**EXPERT-PANEL REVIEW OF CNWRA
COUPLED THERMAL-MECHANICAL-HYDROLOGICAL
PROCESSES RESEARCH PROJECT**

**Nuclear Regulatory Commission
Contract NRC-02-93-005**

**Center for Nuclear Waste Regulatory Analyses
San Antonio, Texas**

September 1995

Figure 1: Relative behavior for TH migration from a heated drift or repository with transport by (a) pressure drive in low permeability materials, (b) buoyancy effects in high relative permeability materials, and (c) buoyant escape from the heated region with return flow by capillary wicking.

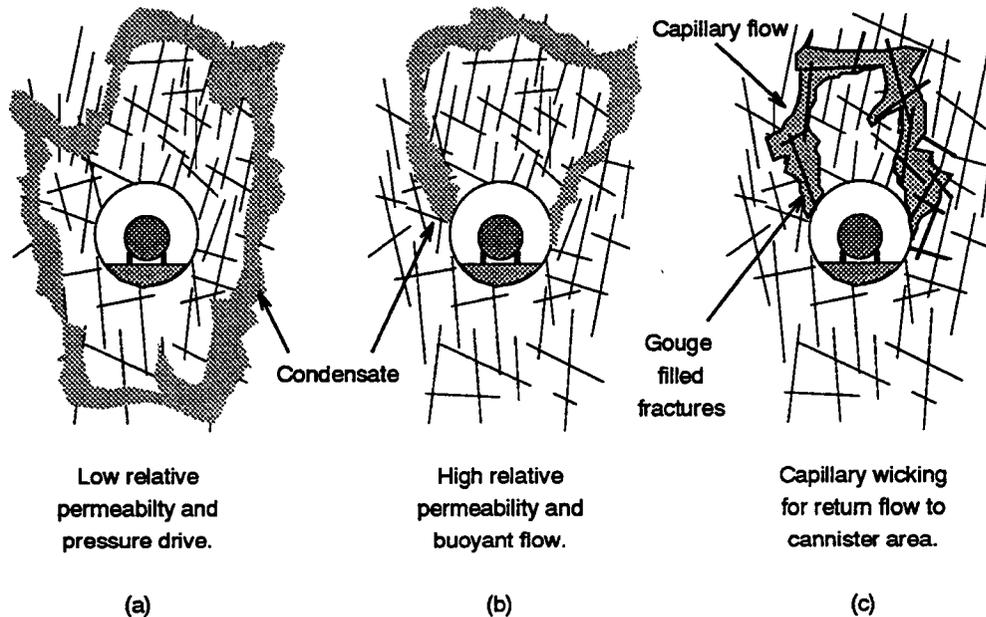
The raw processes governing vapor transport behavior appear well documented (Manteufel et al., 1992) although the constraints on behavior in heterogeneous fractured geologic media seem less certain. This is considered a crucial KTU. A modeling study to evaluate the sensitivity of the resulting behavior to variability in the geological environment is, correspondingly, suggested. The evaluation might include evaluation of behavior for geological environments conceptualized in Figure 1 and characterized by three alternate configurations, namely:

important in evaluating the transport and sorptive characteristics of fractures and fracture zones, and defining the potential for capillary recirculation around the waste packages (see Figure 1).
